**STAFF RECOMMENDATION**

**1516 Ordway Place**

**June 21, 2017**

**Application:** New construction—infill

**1 PROPOSED SOUTH ELEVATION**  
SCALE: 1/8" = 1'-0"  
0 4' 8' 16'

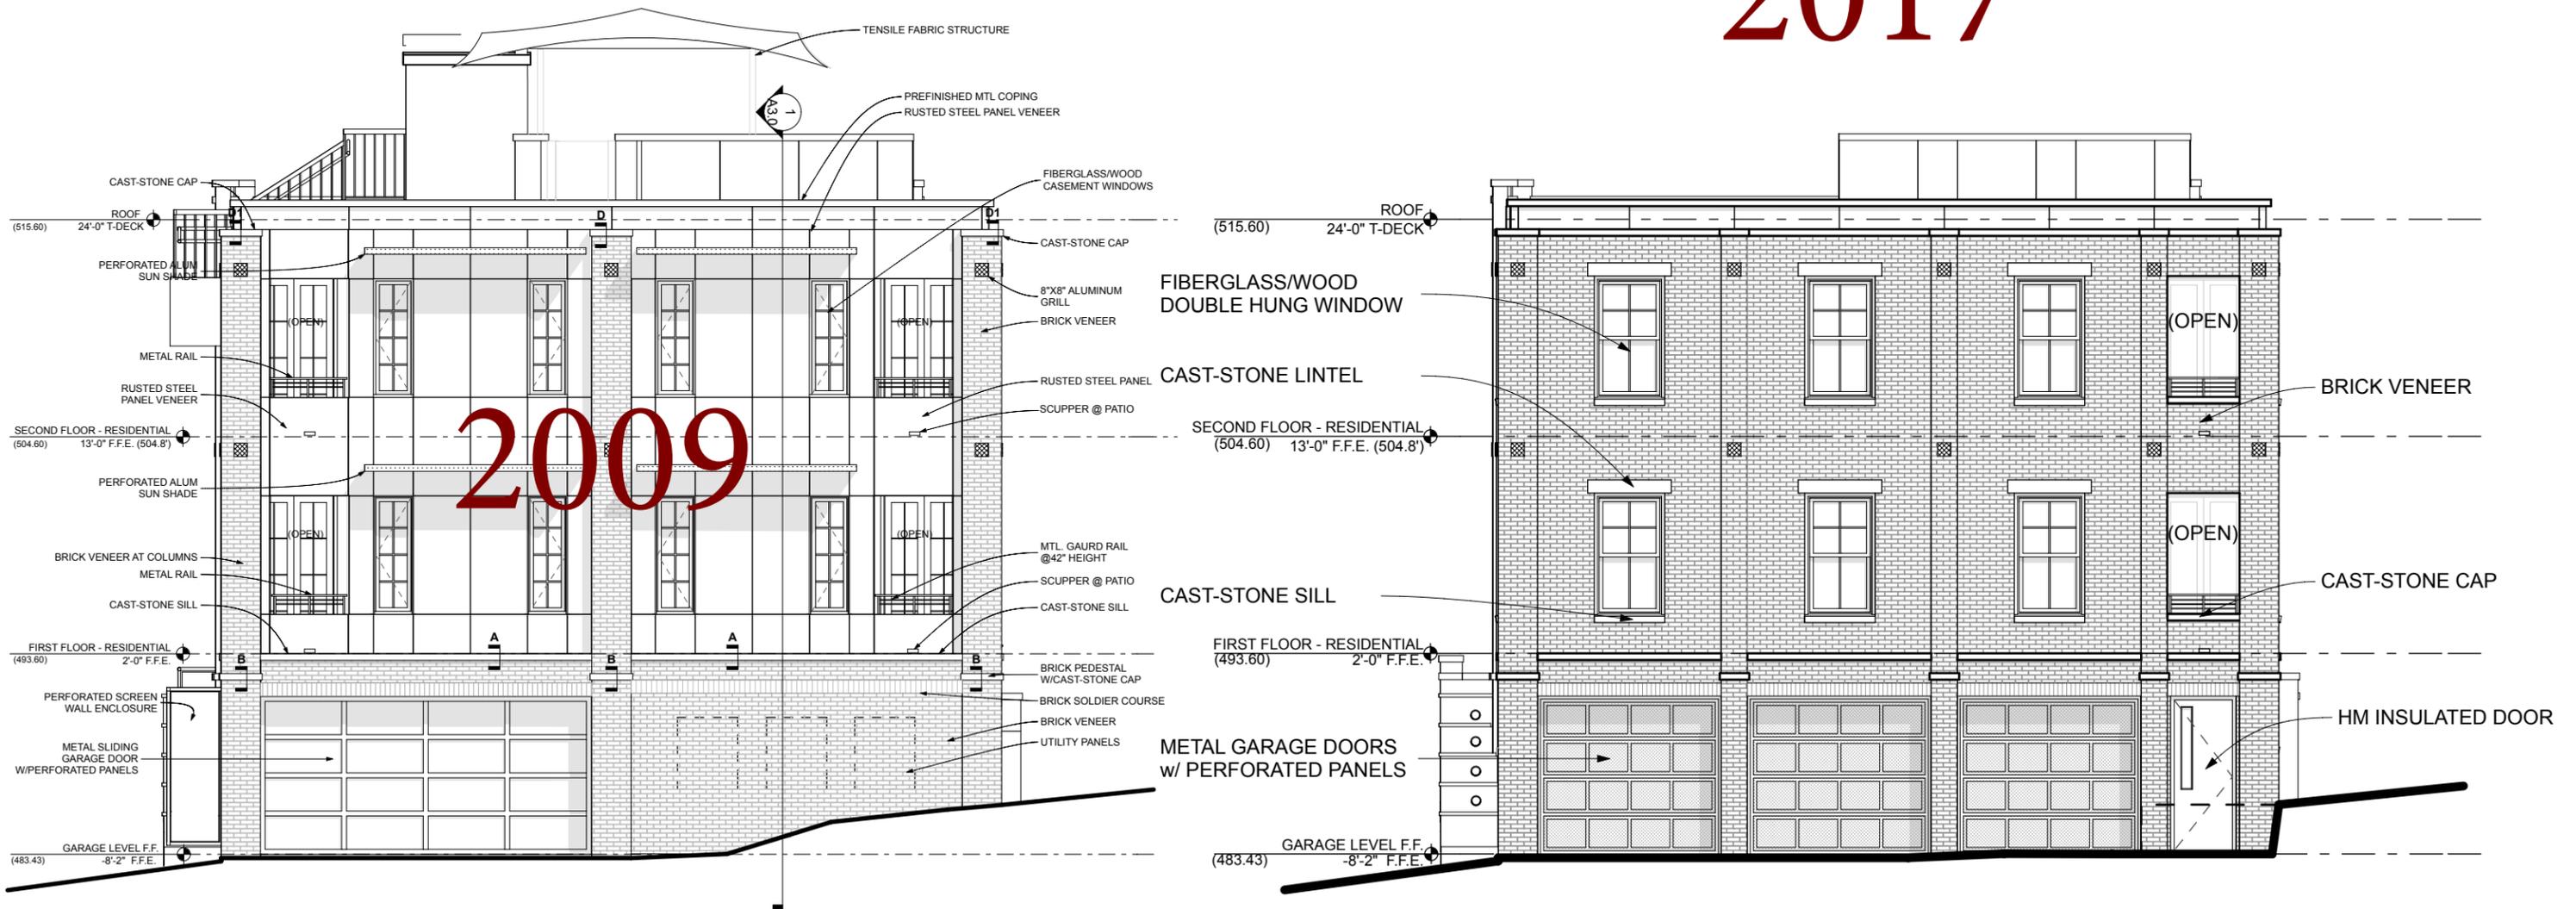
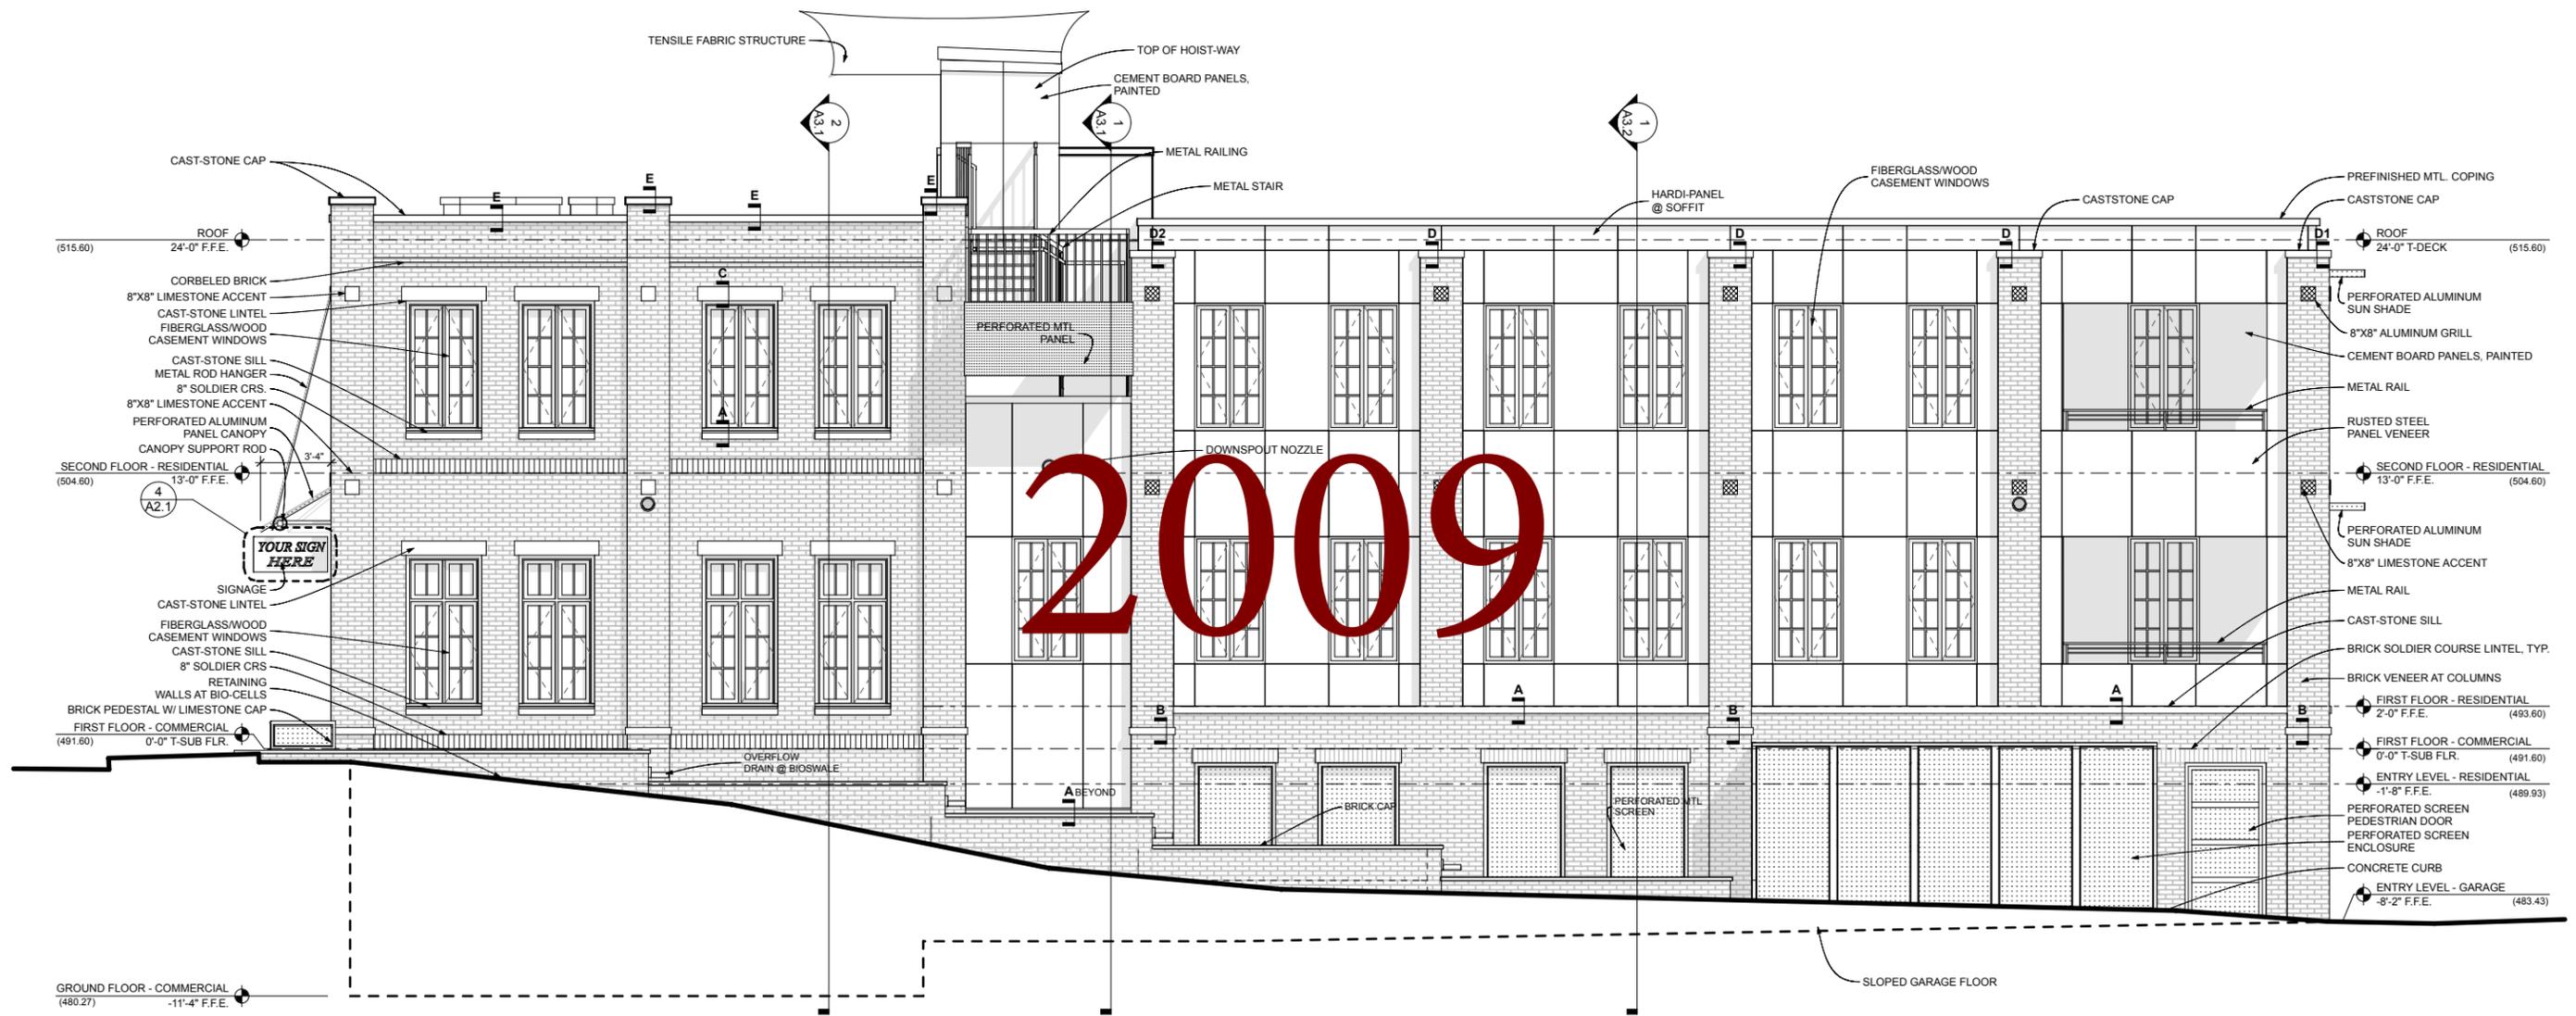
# ELEVATION MODIFICATIONS:

1. CHANGED RUSTED STEEL PANEL VENEER TO BRICK VENEER.
2. REPLACED SLIDING GARAGE DOOR WITH THREE OVERHEAD GARAGE DOORS.
3. ADDED PEDESTRIAN DOOR AT GARAGE.
4. REMOVED PATIOS AT SW CORNER OF BUILDING AND INFILLED WITH BRICK.
5. REMOVED ALUMINUM SUN SHADES ABOVE WINDOWS.

## PROPOSED WEST ELEVATION

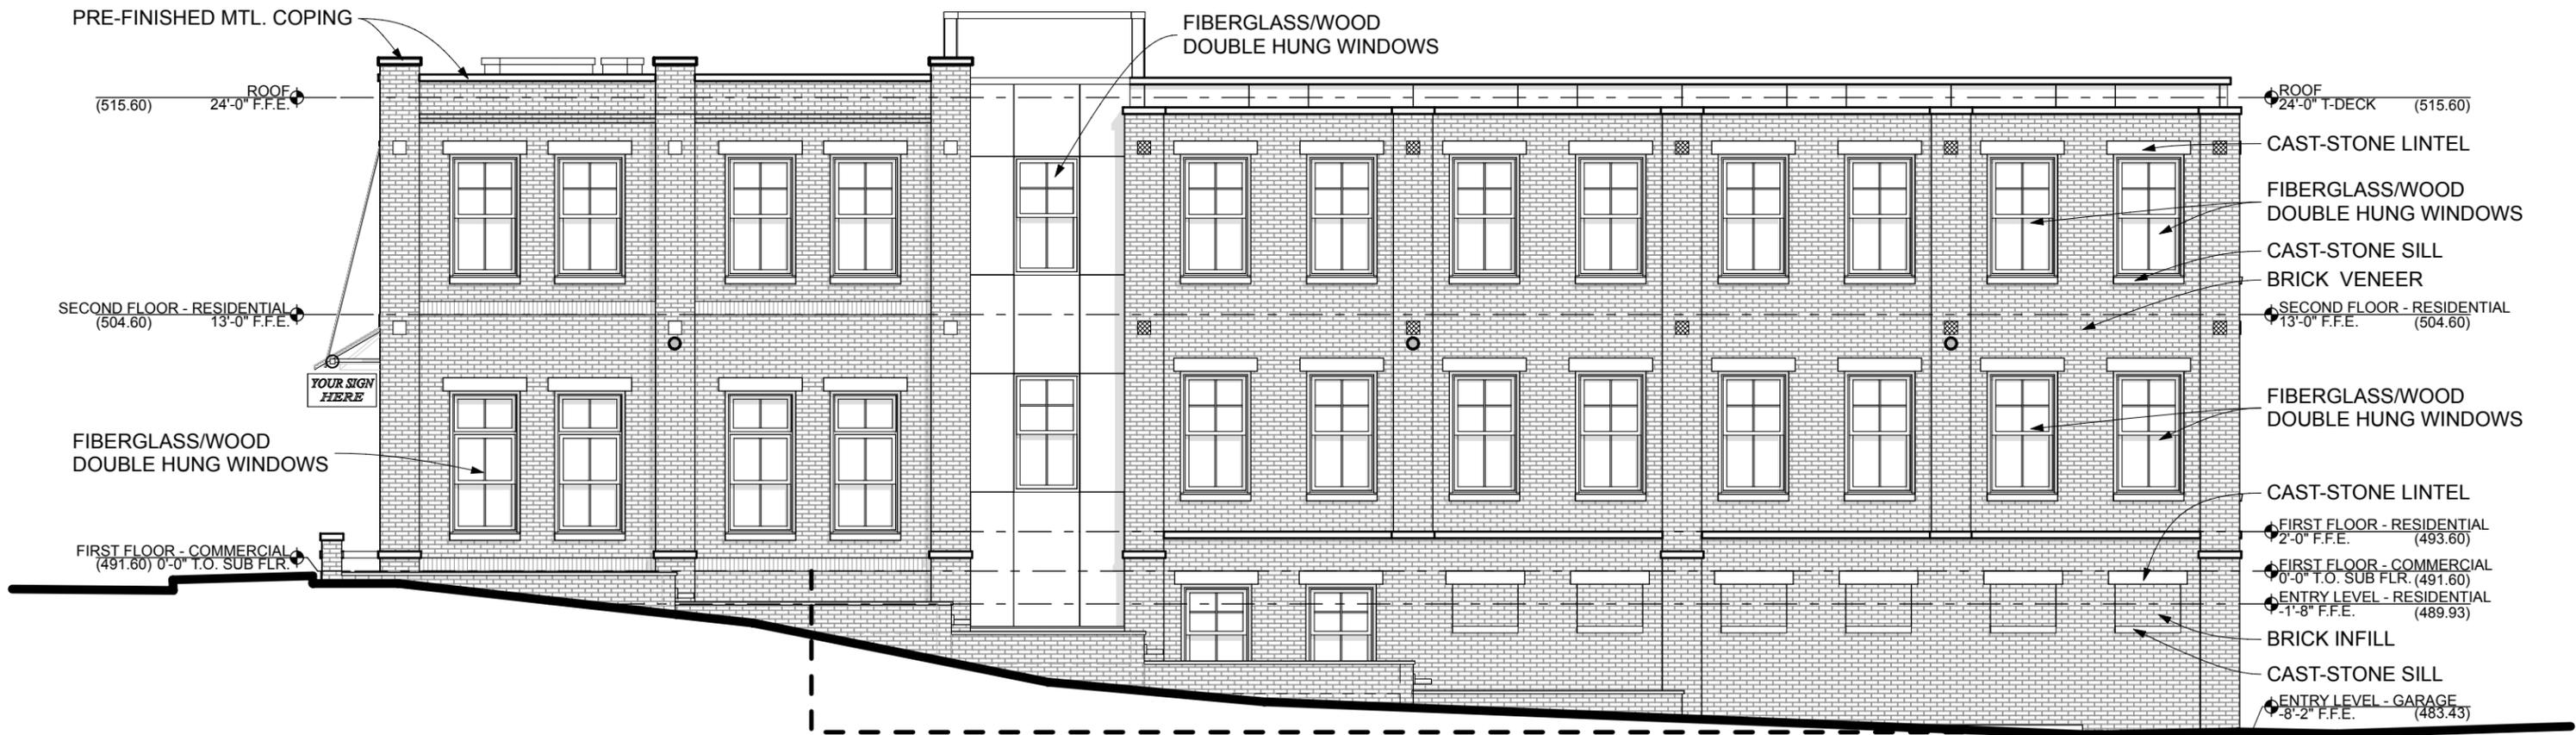
# ELEVATION MODIFICATIONS:

1. CHANGED RUSTED STEEL PANEL VENEER TO BRICK VENEER.
2. CHANGED OPEN AIR GARAGE PERFORATED SCREENS TO BRICK INFILL.
3. REMOVED SCREENED ENCLOSURE AND PEDESTRIAN DOOR AT GARAGE.
4. REMOVED PATIOS AT SW CORNER OF BUILDING AND INFILLED WITH BRICK AND WINDOWS.
5. REMOVED EXTERIOR ROOF ACCESS STAIR.
6. CHANGED CAST-STONE CAP TO PRE-FINISHED METAL COPING AT PARAPET.
